EXCAVATION & FILL PLAN - LOT 2
SCALE 1:50

DA AMENDMENTS:

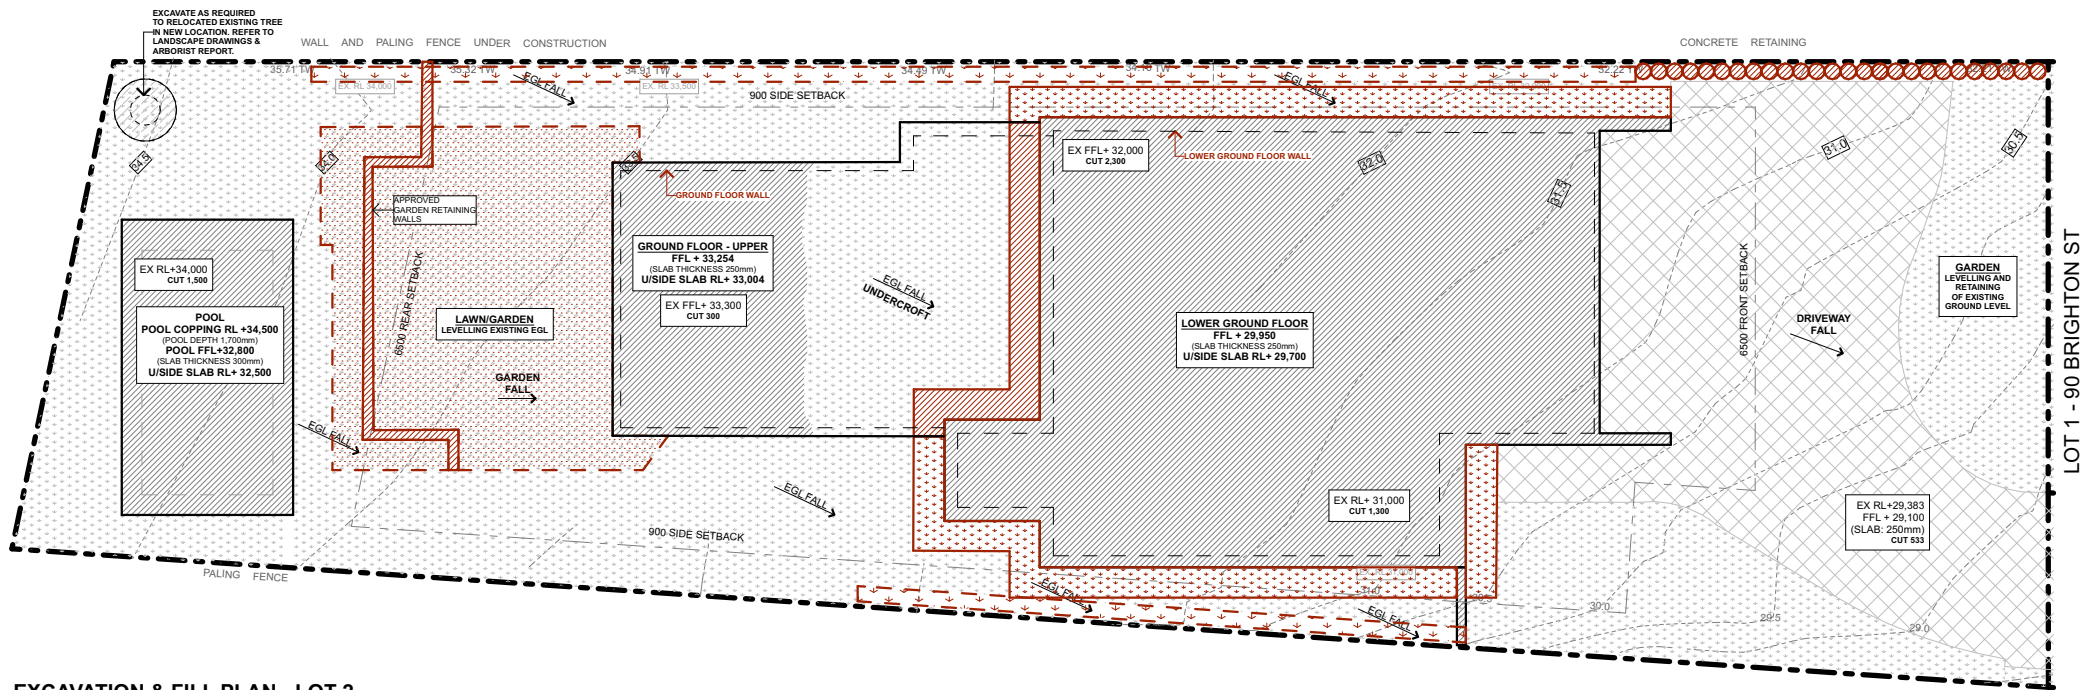
PROPOSED TEMPORARY MASS CONCRETE RETAINING WALLS, TO STRUCTURAL ENGINEER'S ADVICE. RETAINING WALLS TO BE INSTALLED PRIOR OF REMOVAL OF BULK EXCAVATION & ROCK. RETAINING WALL TO FINISH 150MM BELOW EGL, AND TO BE BACKFILLED WITH SOIL OVER AFTER THE BUILDING WALLS HAVE BEEN INSTALLED.

ADDITIONAL EXCAVATION AS PER STRUCTURAL ENG. REQUIREMENTS FOR WALL CONSTRUCTION. TO BE BACKFILLED WITH SOIL AFTER THE BUILDING WALLS HAVE BEEN INSTALLED.

LEVELING OF EGL FOR LANDSCAPE PURPOSES ONLY.
